SUBJECT: REVIEW OF BWIP DOCUMENTS: SD-BWI-TI-226 AND
RHO-BW-CR-150 P

WMGT DOCUMENT REVIEW SHEET

ROCKWELL HANFORD #: SD-BWI-TI-226

TITLE: RHO-BW-CR-150 P - "PORFLO - A Continuum Model for Fluid Flow, Heat Transfer, and Mass Transport in Porous Media"

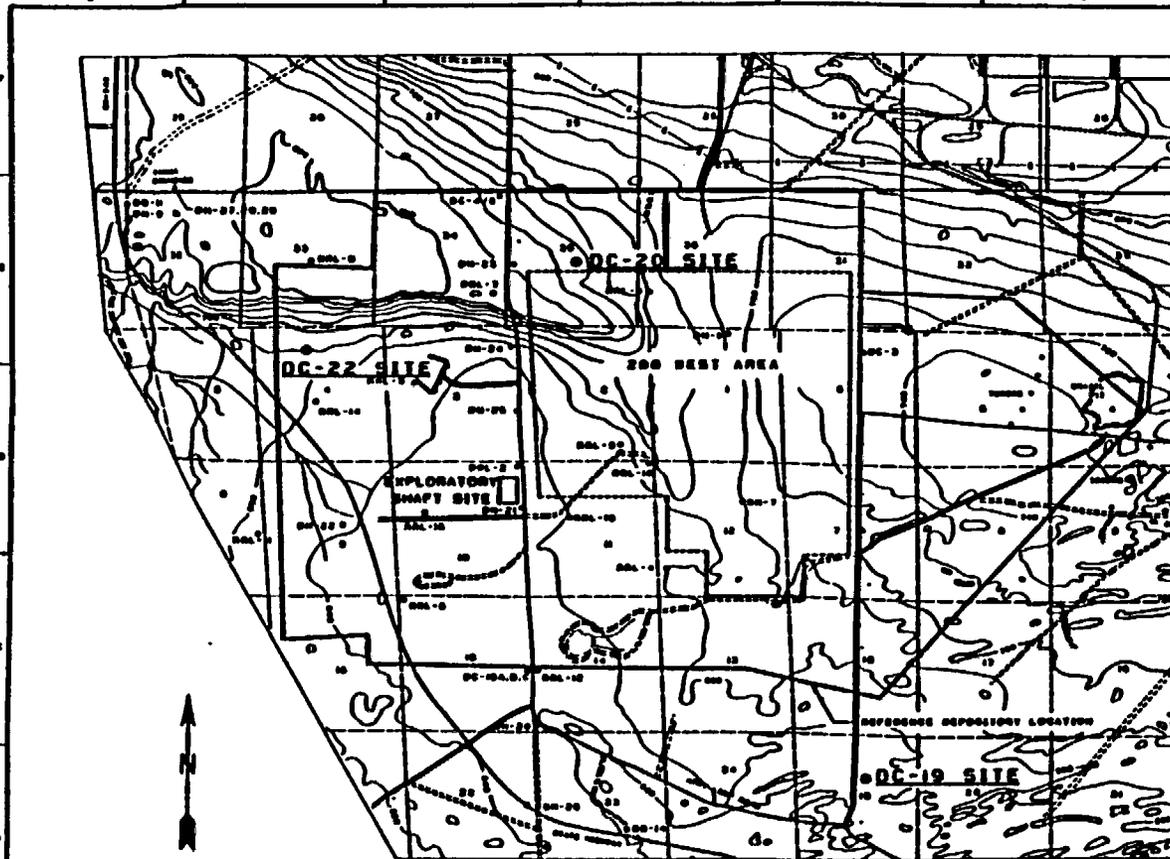
The report states (p. 33) that a 92-foot thick basalt flow is present in borehole DC-19C but it is not present in boreholes DC-20C or DC-22C. The absence of the 92-foot thick flow is of concern because of its potential impact upon hydraulic continuity in an areal sense. The hydraulic gradients that are estimated based on data derived from the cluster sites imply hydraulic continuity of flow path. The absence of the subject basalt flow at the DC-20C and DC-22C sites implies that there may be greater vertical hydraulic interconnection at the pinch-out of this flow than will be found where the flow is present (DC-19C). The presence and absence of this flow and possibly other flows will have to be scrutinized for conceptualizing groundwater flow paths at the BWIP site. STP 1.1 and analogous RHO documents present testing strategies that require the existence of this conceptual model.

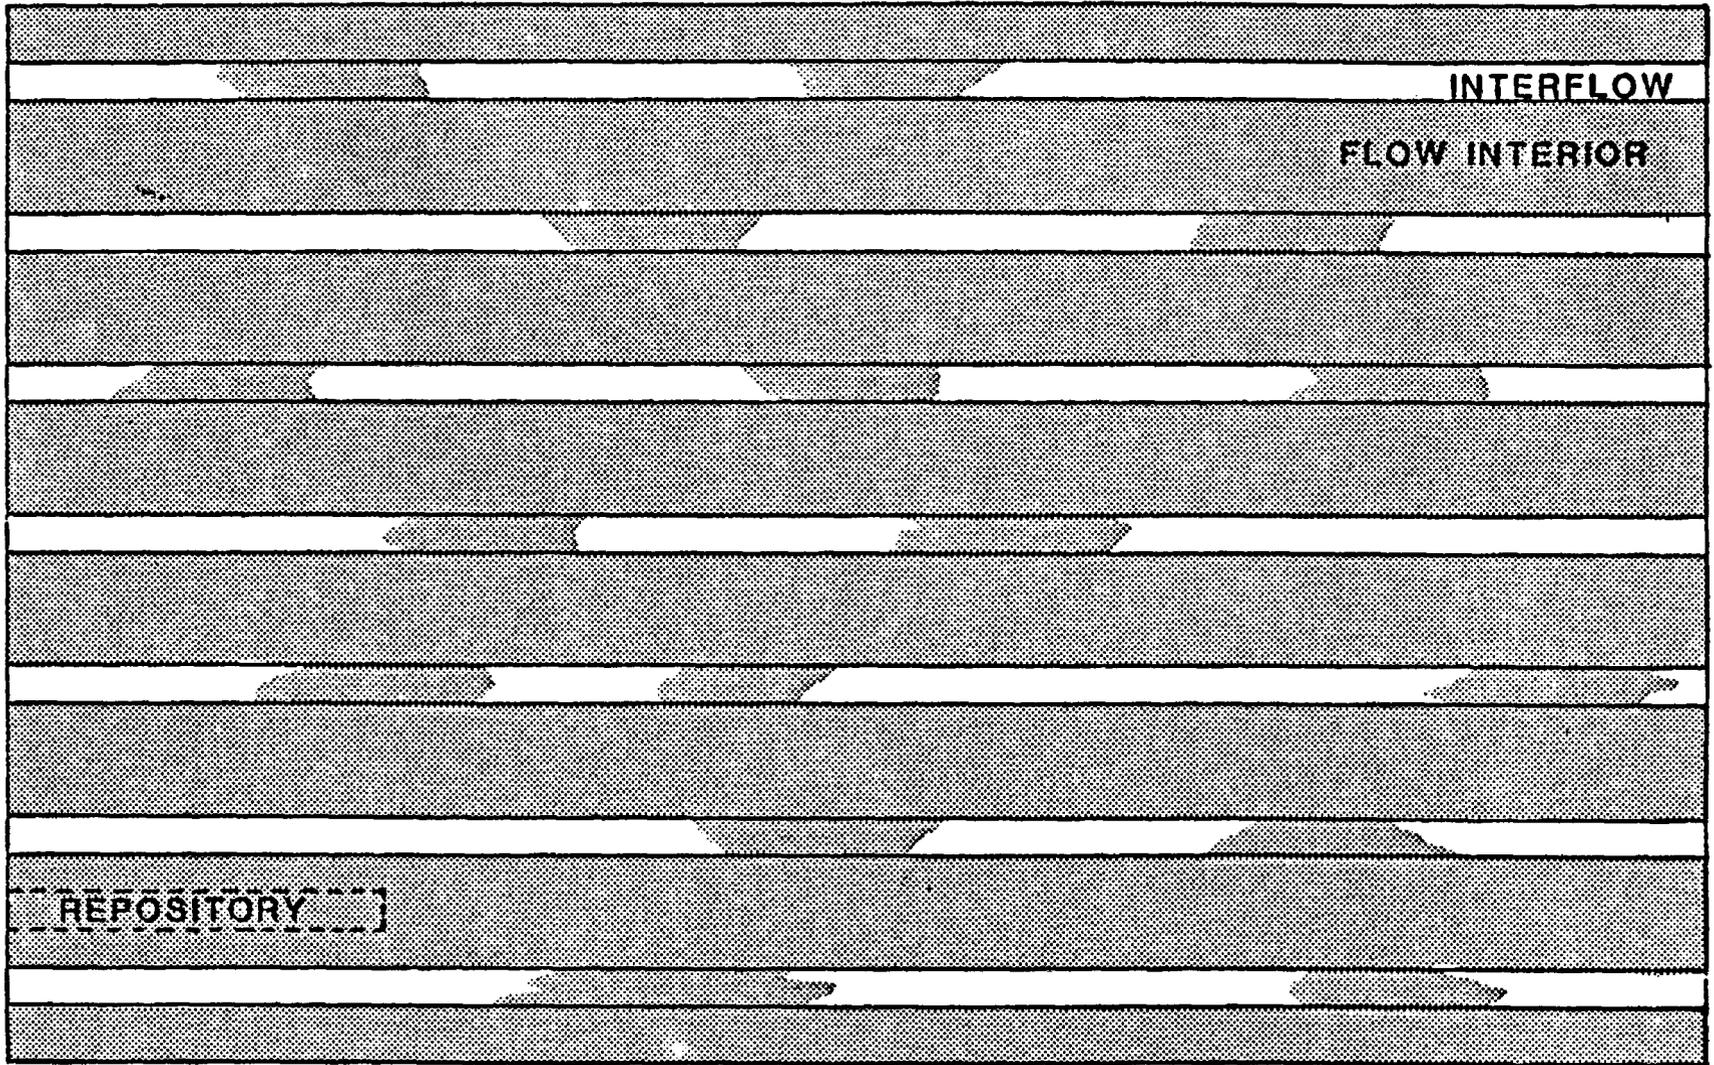
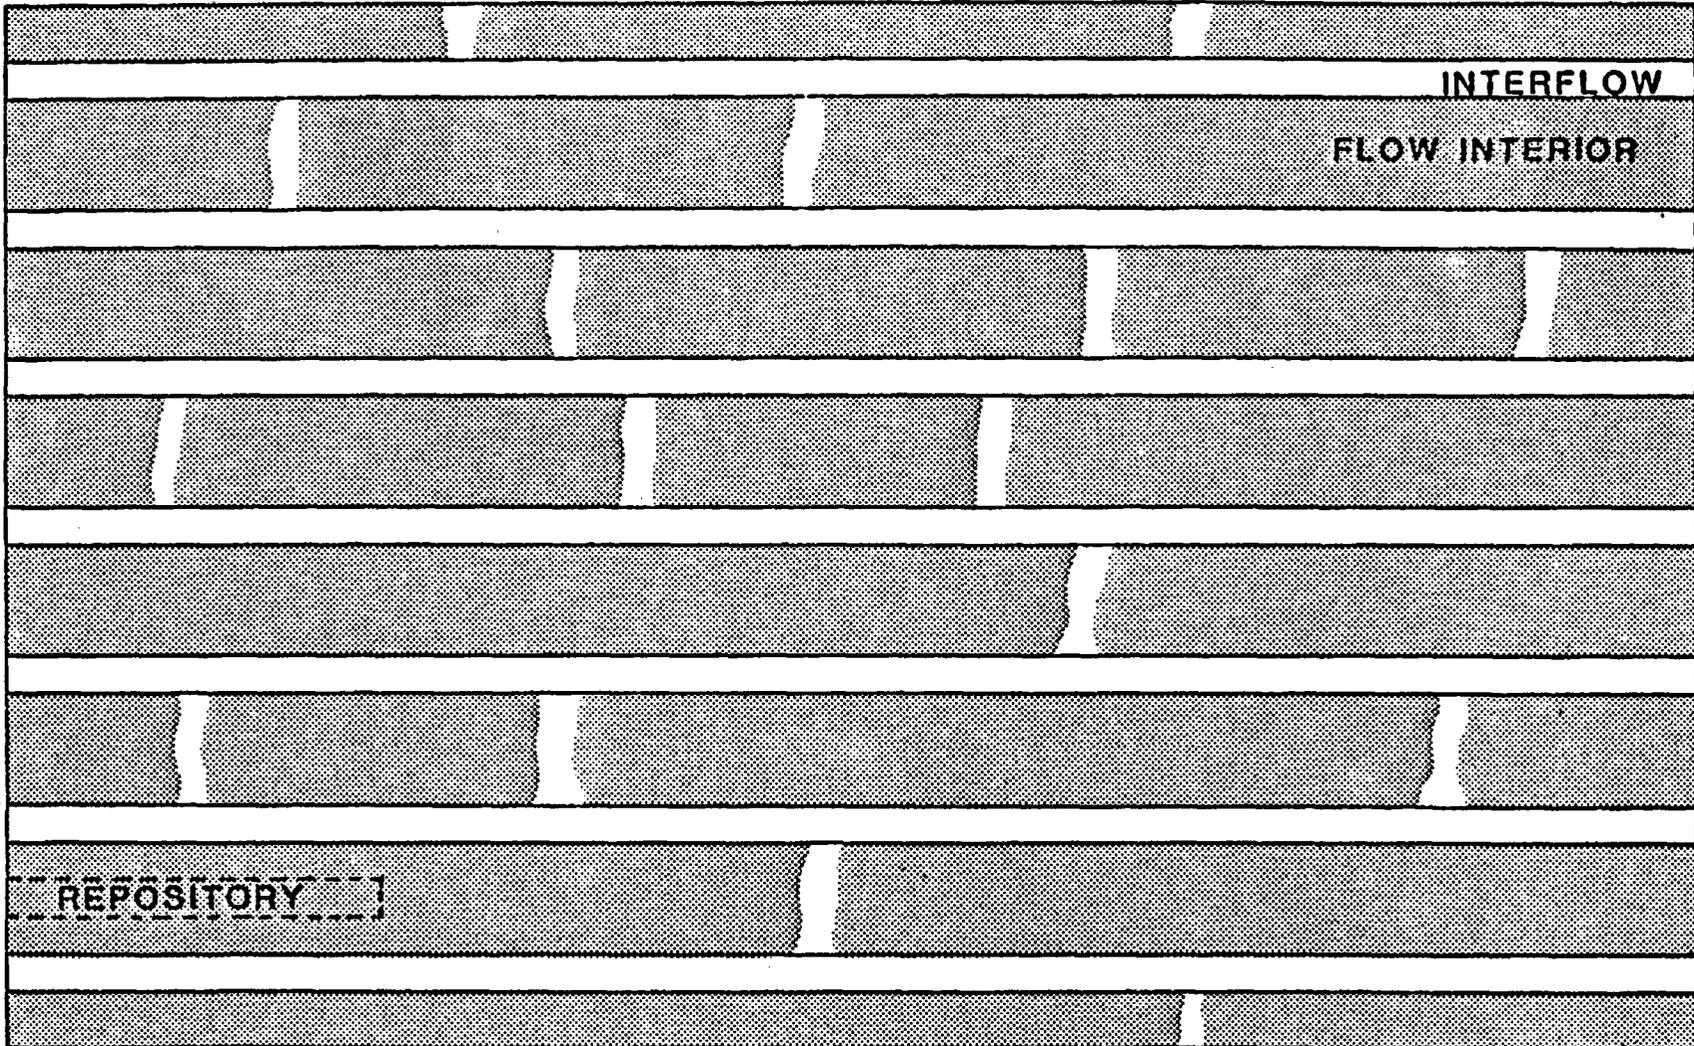
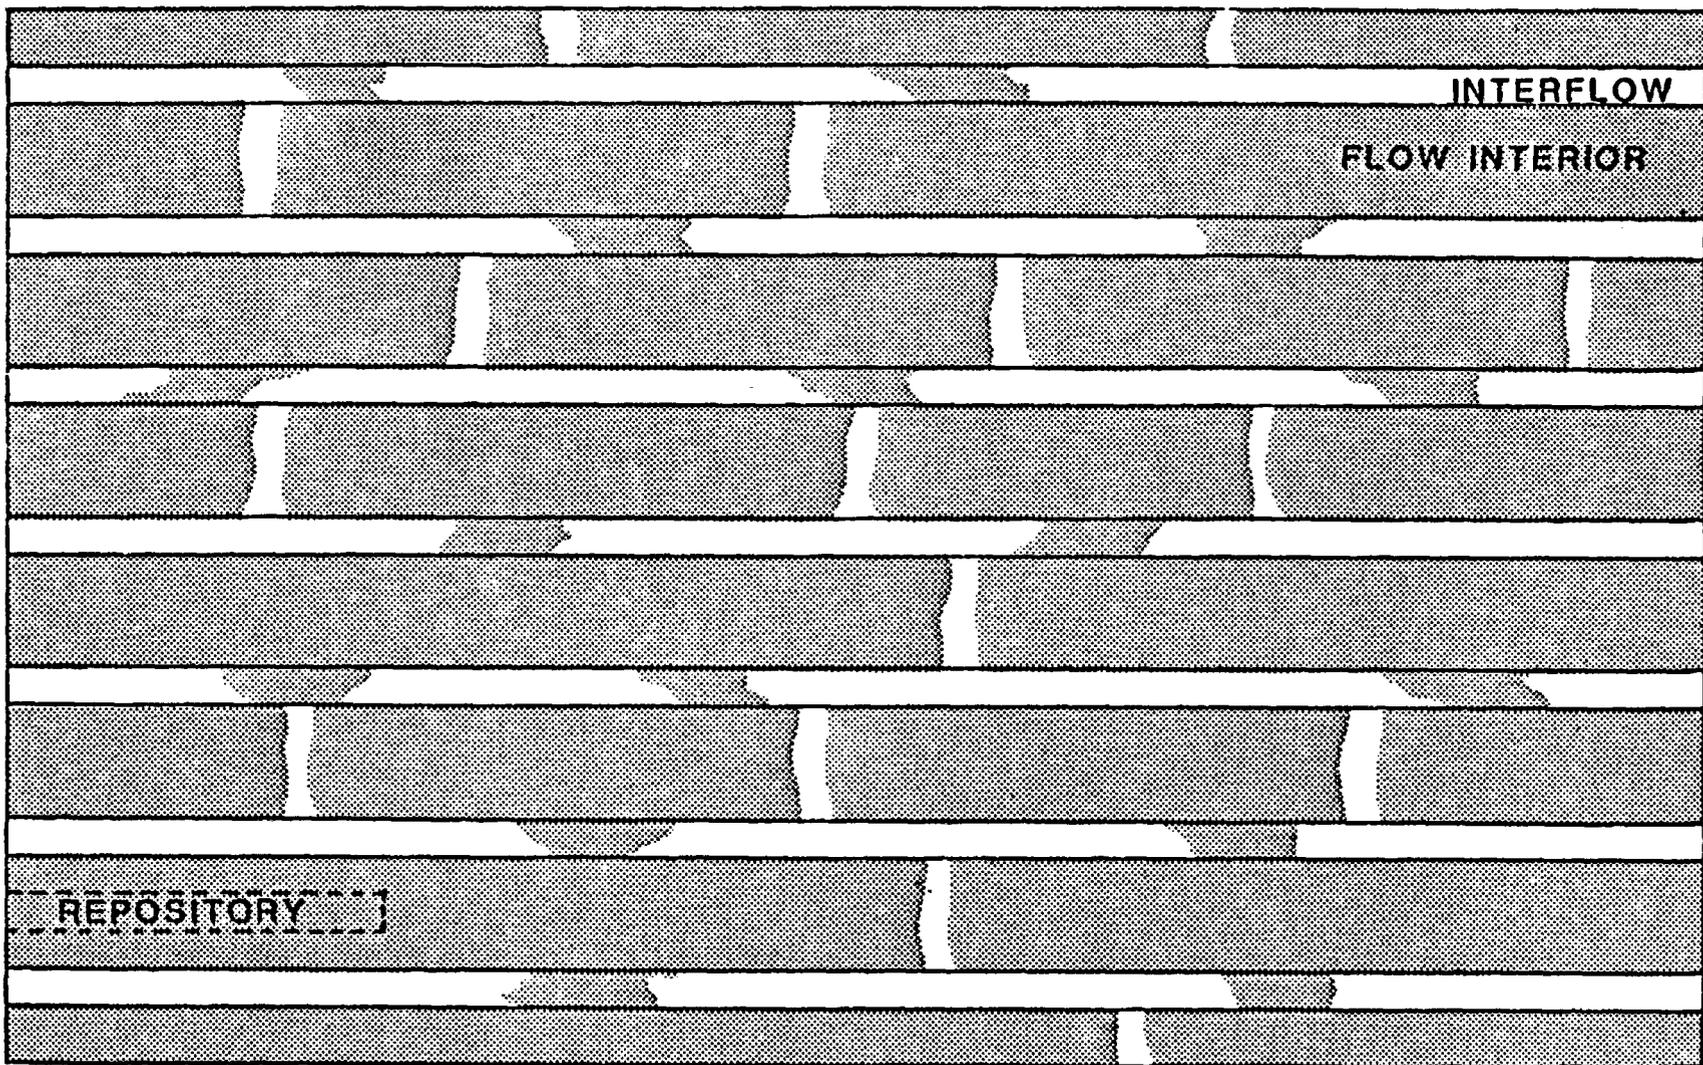
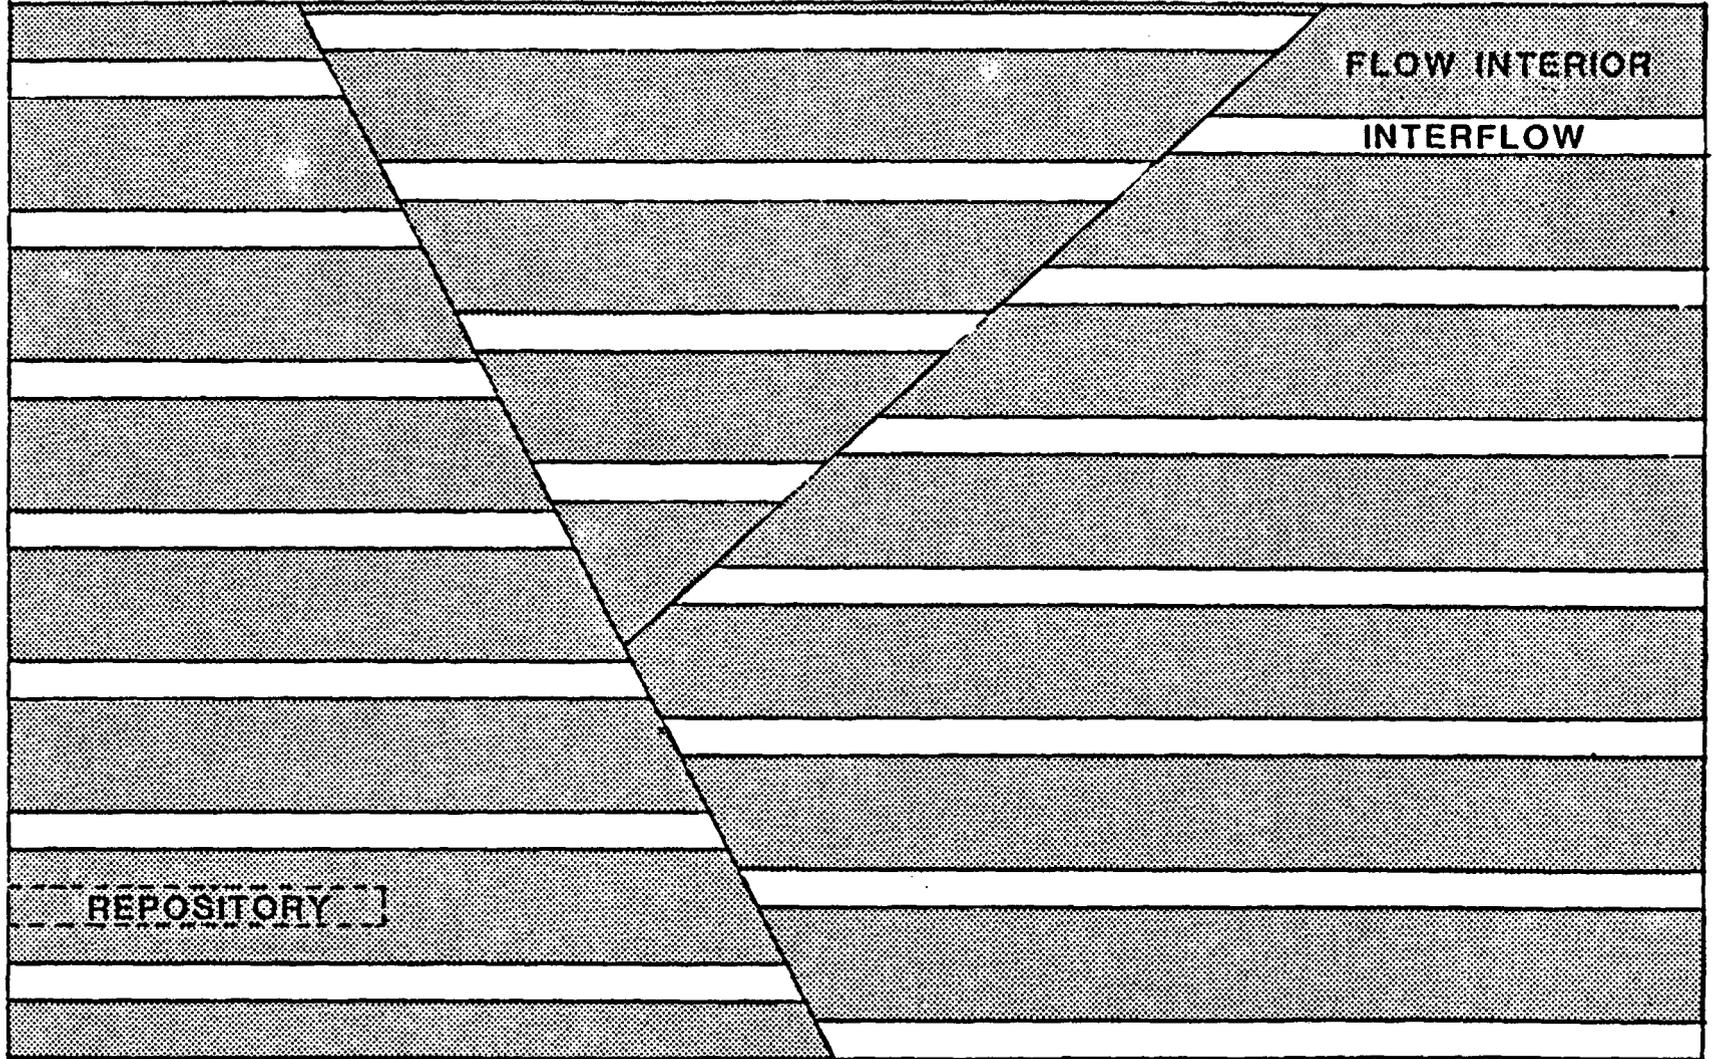
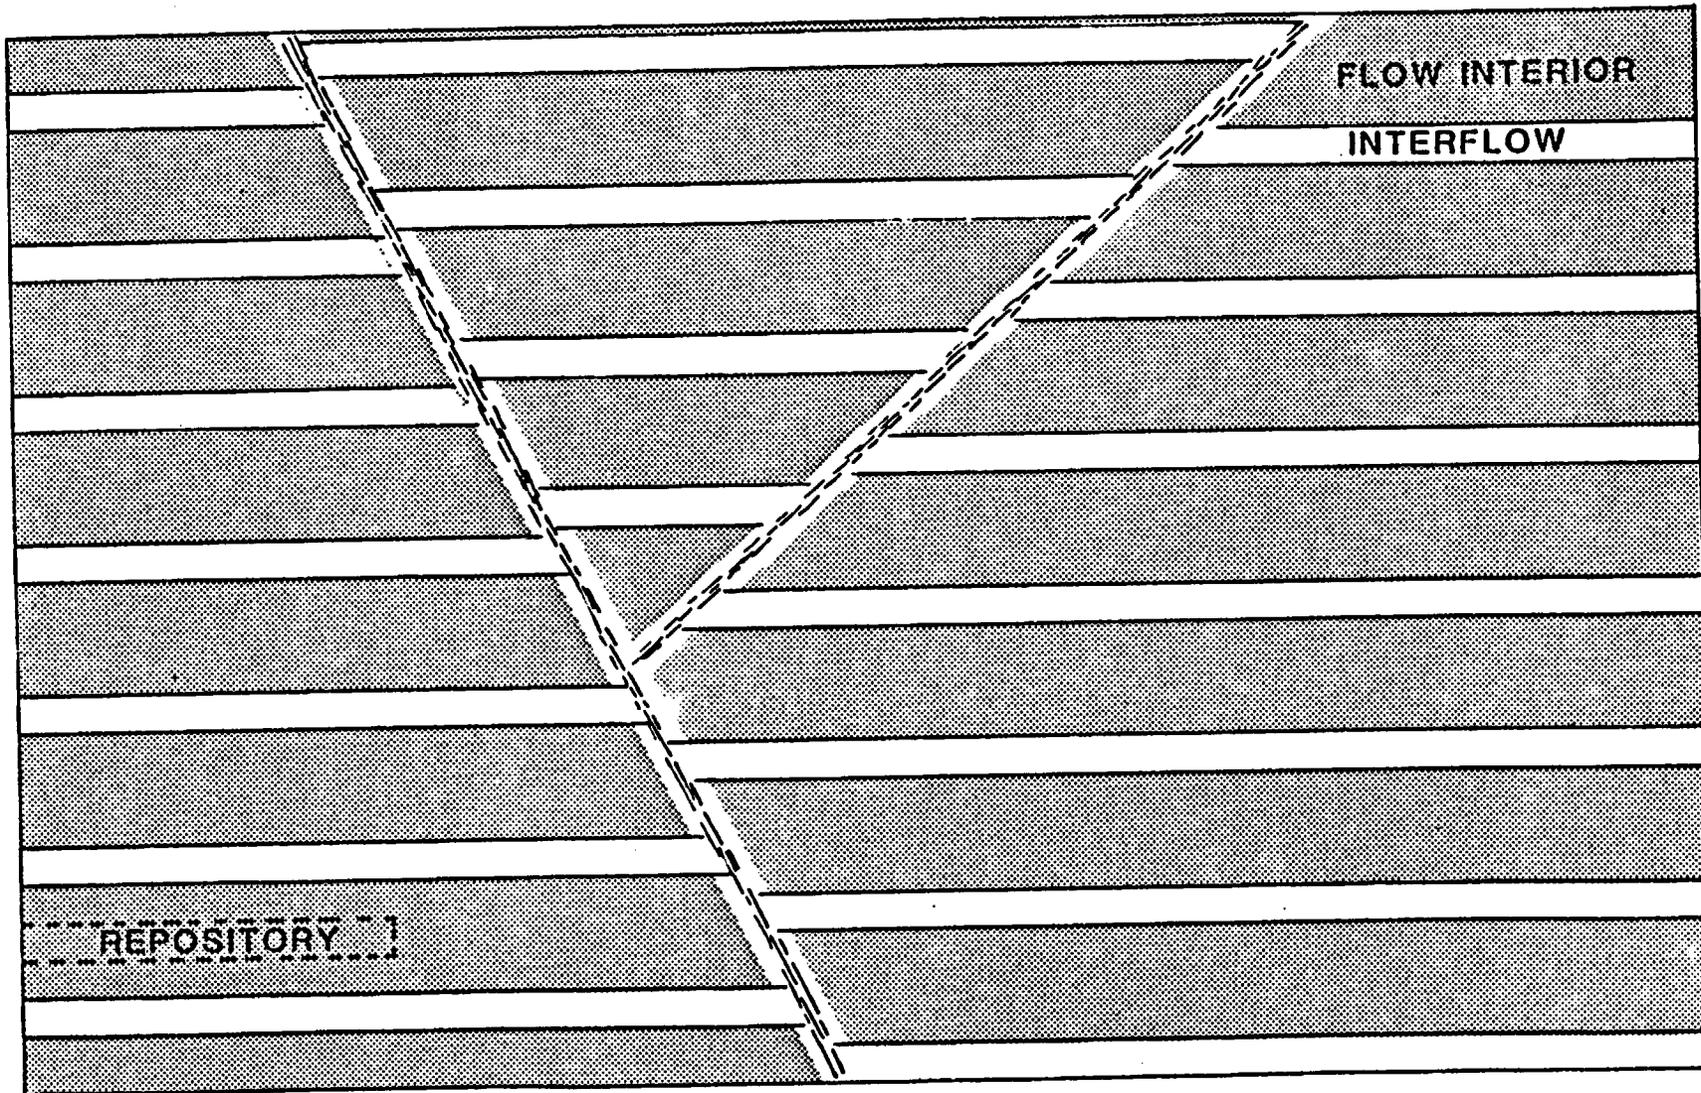
1. Continuously layered; both interflows and flow interiors are relatively homogeneous with assigned bulk parameter values.
2. Continuously layered; interflows are highly heterogeneous with a wide range of parameter values; flow interiors are relatively homogeneous with assigned bulk parameter values.
3. Continuously layered; interflows are relatively homogeneous with assigned parameter values; flow interiors are heterogeneous with isolated high permeability features.
4. Continuously layered; interflows are heterogeneous with a wide range of parameter values; flow interiors are heterogeneous with isolated high permeability structures.
5. High permeability discontinuities within the flow system combined with either 1, 2, 3, or 4.
6. Low permeability discontinuities within the flow system combined with either 1, 2, 3, or 4.

These conceptual models for performance assessment are illustrated in Figures 1 through 6, respectively. As new data become available for the BWIP site, it is anticipated that certain aspects of the above models will be refined, combined, or eliminated from consideration.

A two-dimensional, horizontal model geometry could be applied to simulation of regional flows under Concepts 1 or 2, where both diffuse and discrete vertical transport through the flow interiors can be neglected or applied uniformly without large error. (A possible exception is that flow interiors with low hydraulic conductivity may have significant thermal conductivities that should not be neglected or "blanketed" in the model). Assuming that thermal conductivity of the flow interior is, along with the other transport characteristics of the flow interior, relatively low, the two-dimensional, cartesian model could be applied to a horizontal section of a single flow or interflow, in which either homogeneous or heterogeneous aquifer characteristics can be simulated. It is recommended for this type of application that only a single interflow be modeled, in preference to modeling an entire flow or sequence of flows.

The two-dimensional model could be applied to a vertical section under Concepts 1 and 2 if the model can be aligned parallel to the regional direction of horizontal flow, if interflow heterogeneities do not appreciably alter local horizontal flow directions, and if interflow heterogeneities can be incorporated into the model using bulk parameter values. In this case, flow interiors, as well as interflows, would be modeled as "active cells".

For Concepts 3 and 4, a horizontal, cartesian geometry may be appropriate, if the isolated, high-permeability flow interior features either do not exist in the modeled area, or can be defined adequately using source/sink terms. It

is doubtful that the model could be applied in vertical section because interflows would have some degree of radial (non-two-dimensional) flow towards the isolated high permeability features.

For Concepts 5 and 6, the applicability of a two-dimensional model in horizontal plane would be very limited because flows of mass, heat and radionuclides may be dominated by three-dimensional geometry. Applications would probably be limited either to relatively small regions, where major structural discontinuities are not present, to very large regions, where the scale of the model is much larger than the effective spacing of major structural discontinuities or to areas for which the discontinuities can be treated as boundary conditions or line source/sinks. The two-dimensional model could be applied in vertical section if the modeled area is aligned parallel to the regional flow direction and roughly perpendicular to the discontinuities (to minimize non-uniformity in the third dimension not modeled).
